City of Brisbane

Planning Commission Agenda Report

SUBJECT: **Grading Review EX-3-18; 151 West Hill Place;** TC-1 Crocker Park Trade Commercial District; Grading Review for expansion of the parking lot and construction of an approximately 1,350 square foot accessory vehicle maintenance structure, requiring approximately 424 cubic yards of soil to be exported from the site; Joe Breedlove, applicant; Frito Lay Sales Inc, owner.

PHASE 2
PARKING GRADING IMPROVEMENT PLAN FOR
151 WEST HILL PLACE
APN: 005-300-140 AND A PORTION OF APN 005-300-010
CITY OF BRISBANE CALIFORNIA

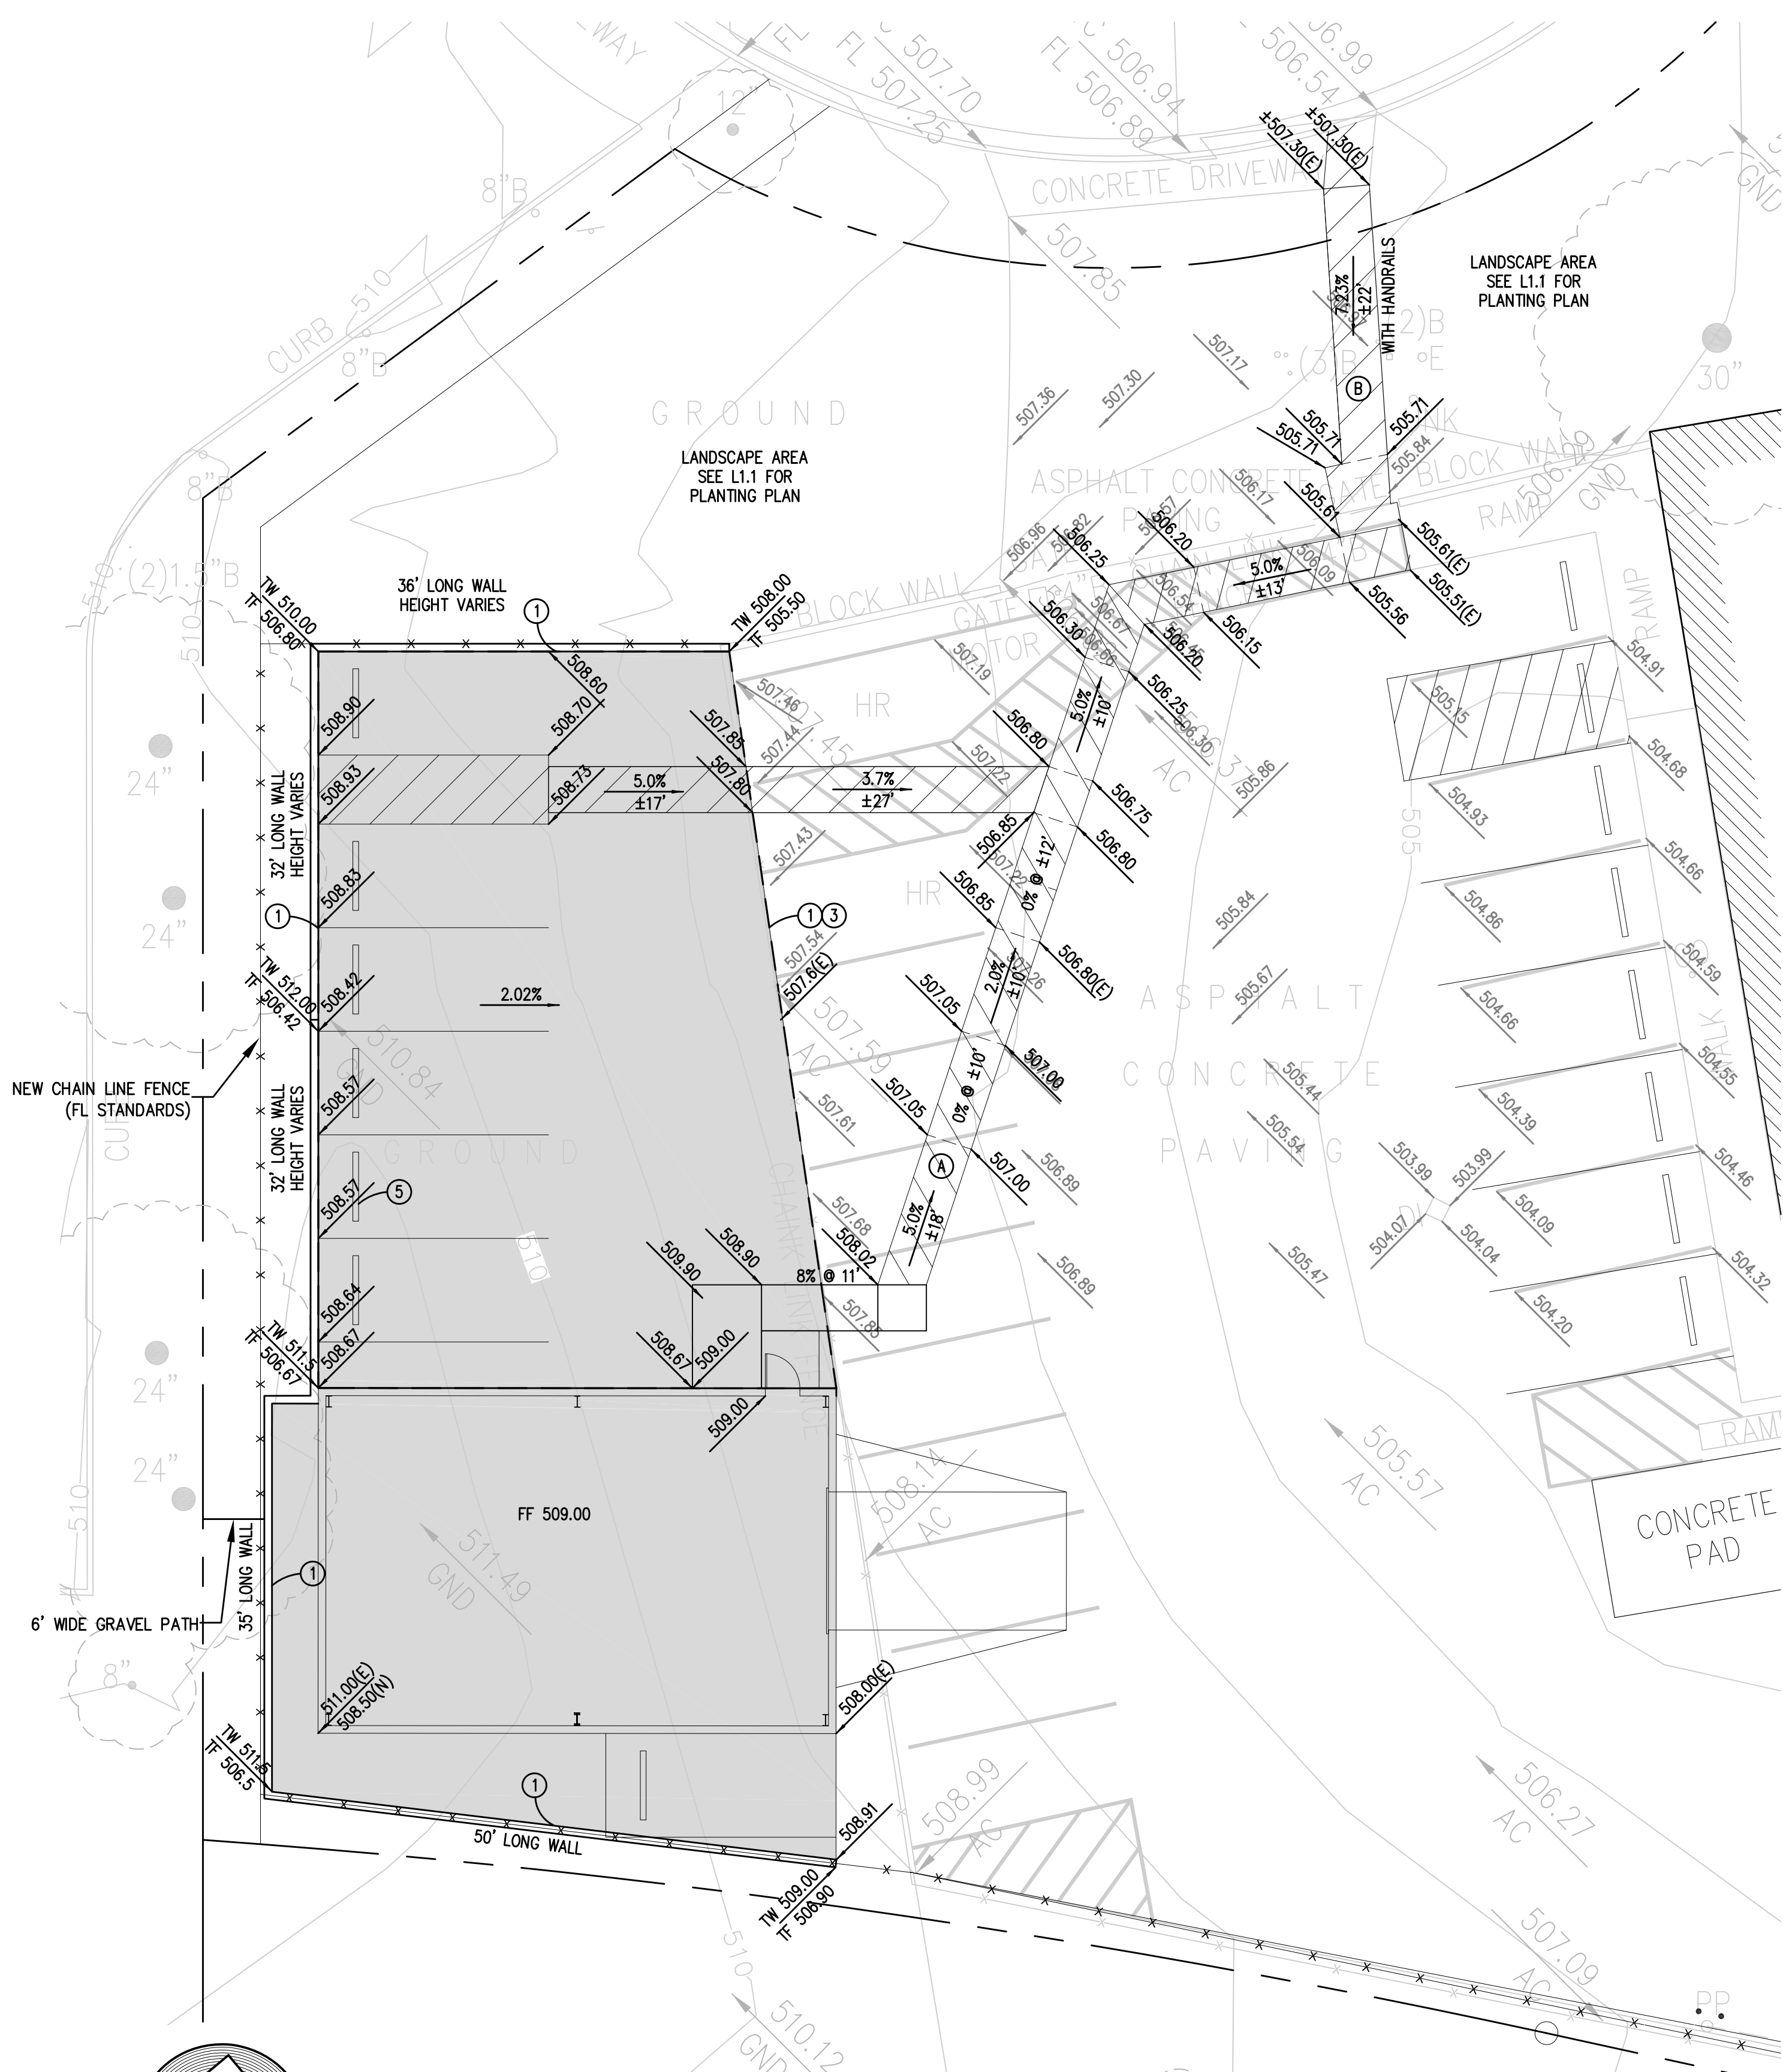
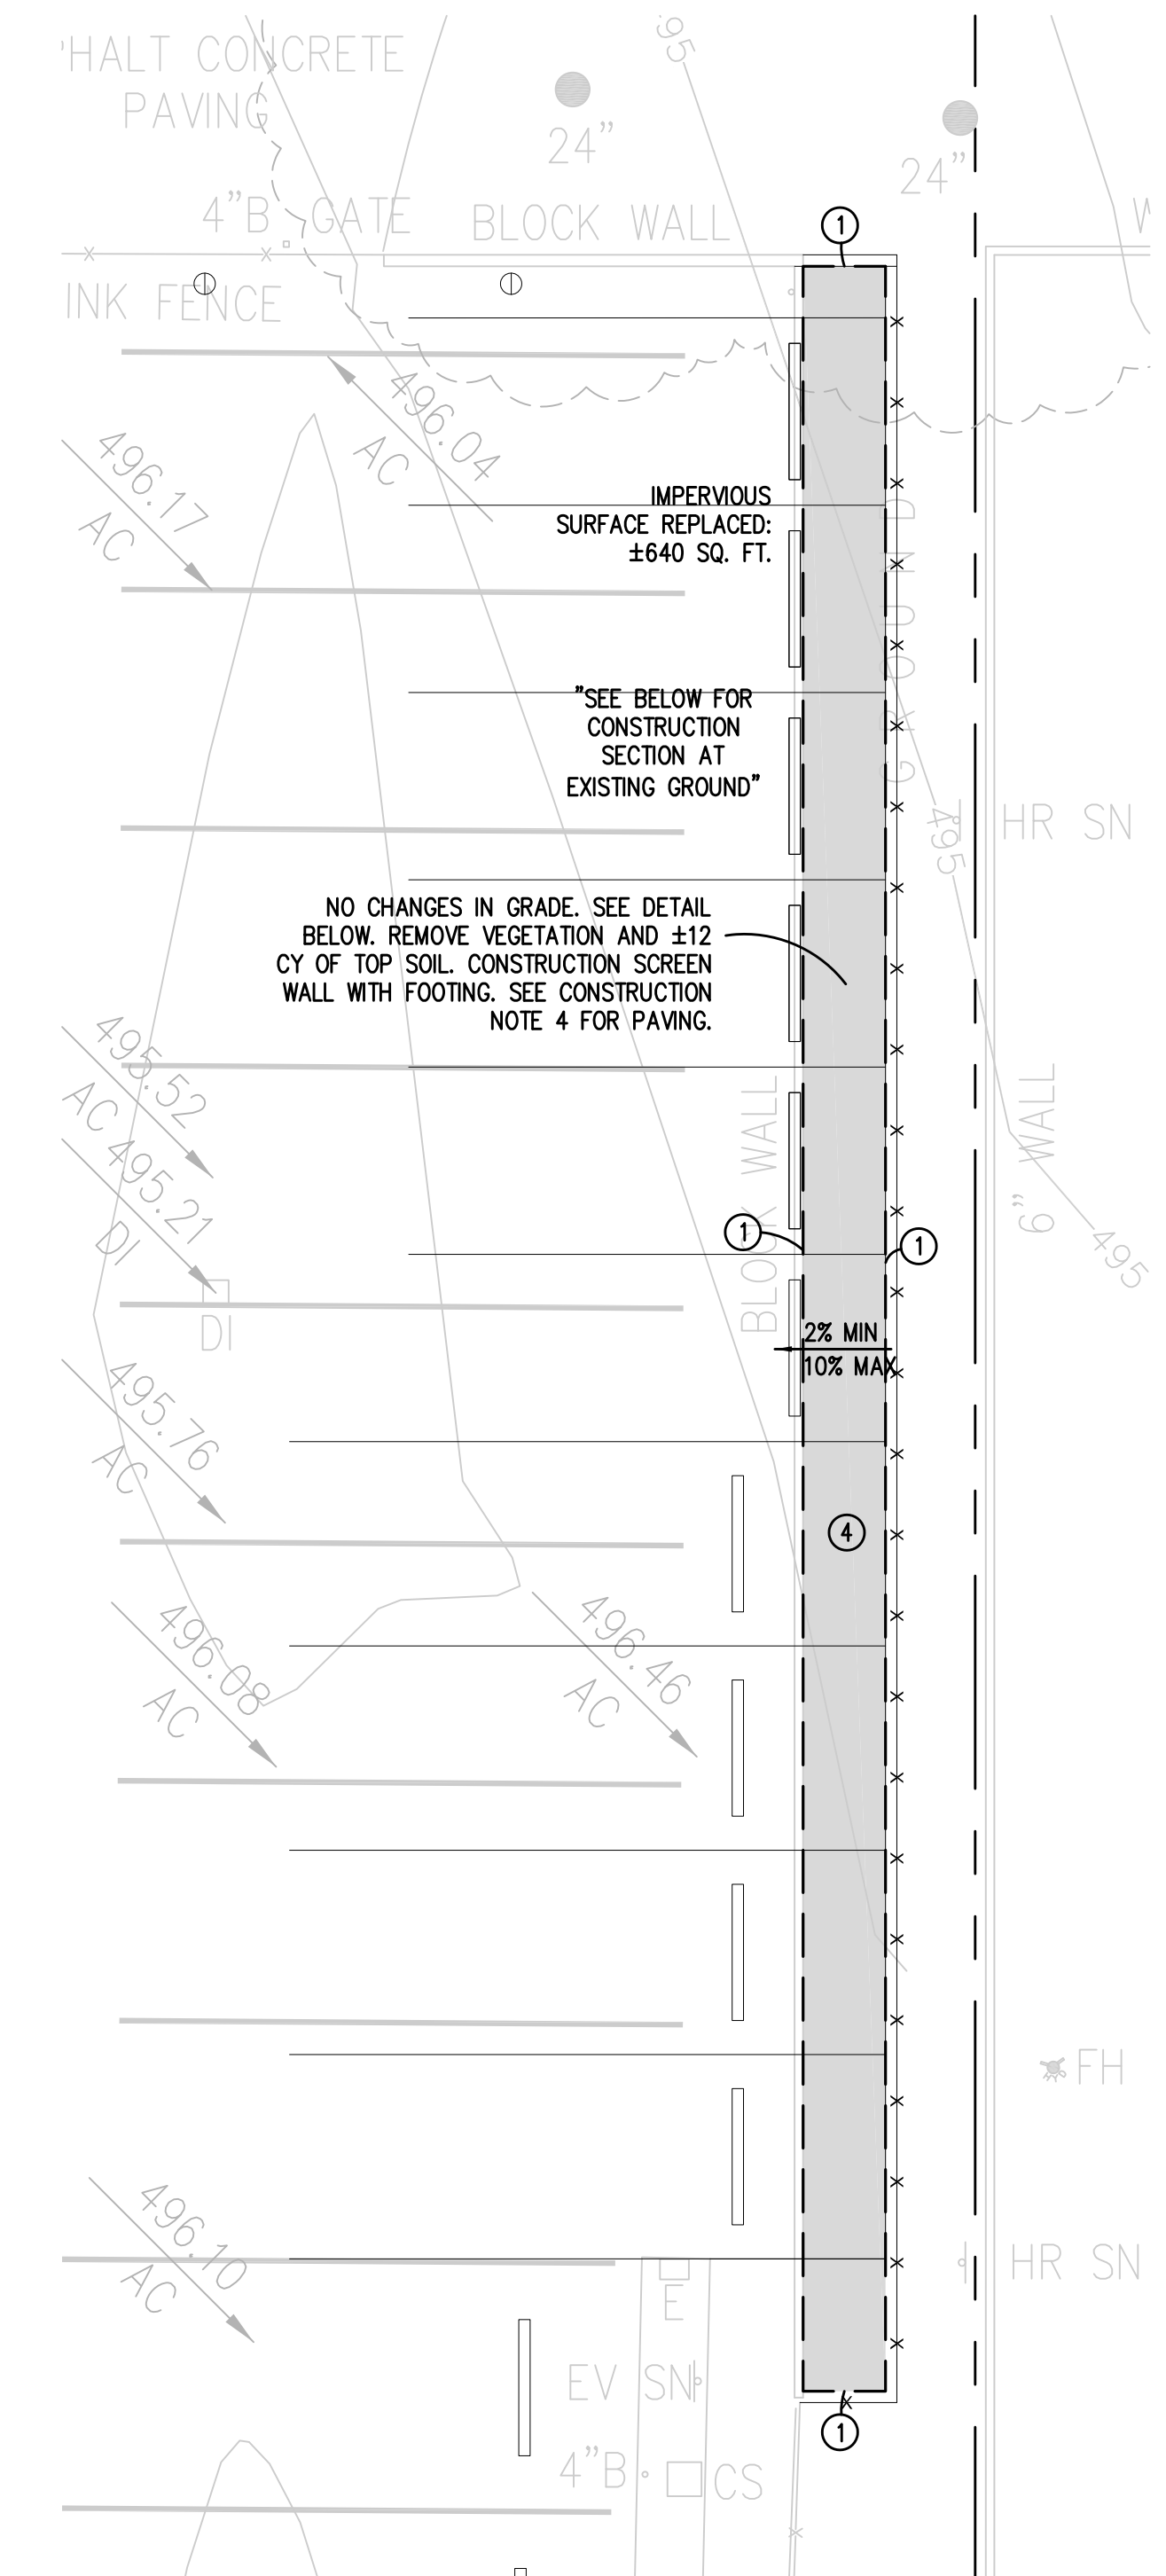
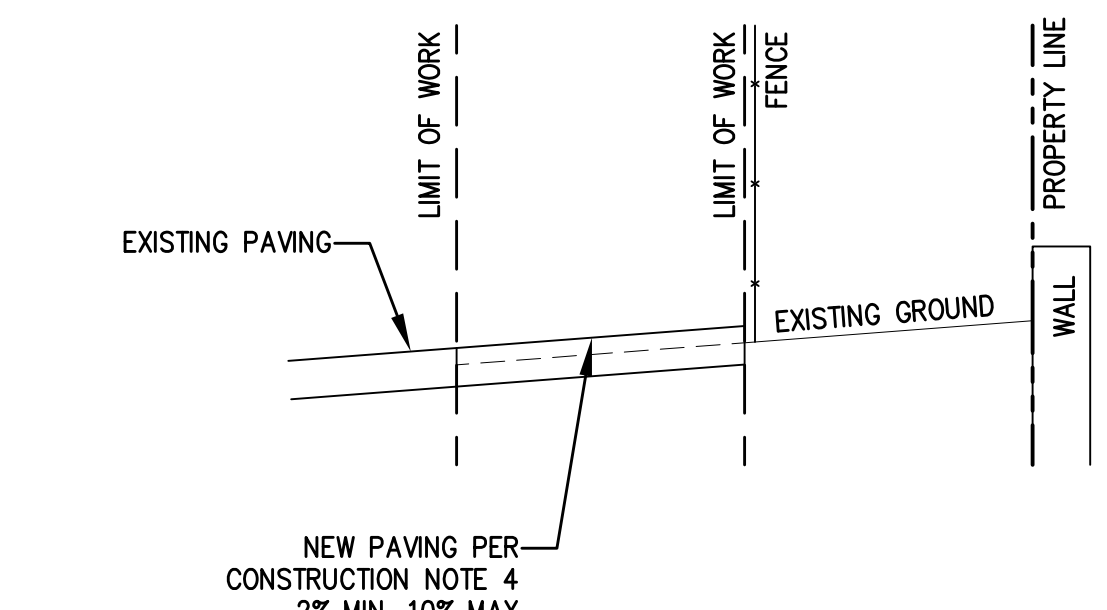
Note that the plan provided by the applicant shows the area to be graded in grey with the proposed building and proposed parking within that area on the western side of the site. The existing parking stalls, to be removed, are also shown on that same plan as faded back lines. While the parking layout would be altered with this proposal, the on-site parking would remain conforming. Some spaces would be added along the rear, southern edge of the site. It would have 55 spaces, which is 34 more than the required minimum of 21.

On the east side of the site, the grading plan shows a narrow strip of land that is also shaded in grey. For that area, the parking lot would be widened by a few feet and so that area would be paved and a landscape strip would remain and would be planted between this parking area and the neighboring parking area to the east for 115-127 West Hill Place. The widening of this parking area would also allow for flexibility in the size of the vehicles that can park there. The applicant has indicated that for that area there would be nominal to no net change in grading, but the area would just be paved to widen this parking lot area.

The application meets this finding. The proposed grading would cut into the slope along the western edge of the site, totaling approximately 424 cubic yards of soil to be taken off site. The amount of grading is the minimum necessary to allow for expansion of the parking lot to match the existing grade levels and placement of the accessory building. The exposed portion of the retaining wall would range from 1 to 4 feet along the western edge of the parking lot, dropping to

approximately 0.5 feet at the eastern ends. This is modest in scale, so the overall effect is to only grade what is necessary for the project.

The application meets this finding. As indicated above, the proposed grading would result in a modest scale retaining wall adjacent to the parking lot, ranging up to approximately 4 feet in height with a step down midway along its length to match the topography.

- A. The proposed grading is minimized and designed to reflect or fit comfortably with the natural topography.
- B. The proposed grading is designed to avoid large exposed retaining walls, with the proposed retaining wall exposure being up to approximately 4 feet.
- C. The proposed grading would not result in the removal of existing street trees, California Bay, Coast Live Oak, or California Buckeye trees nor three or more trees of at least 30 inches measured 24 inches above natural grade.
- D. The proposed grading is not within the area of the San Bruno Mountain Area Habitat Conservation Plan.
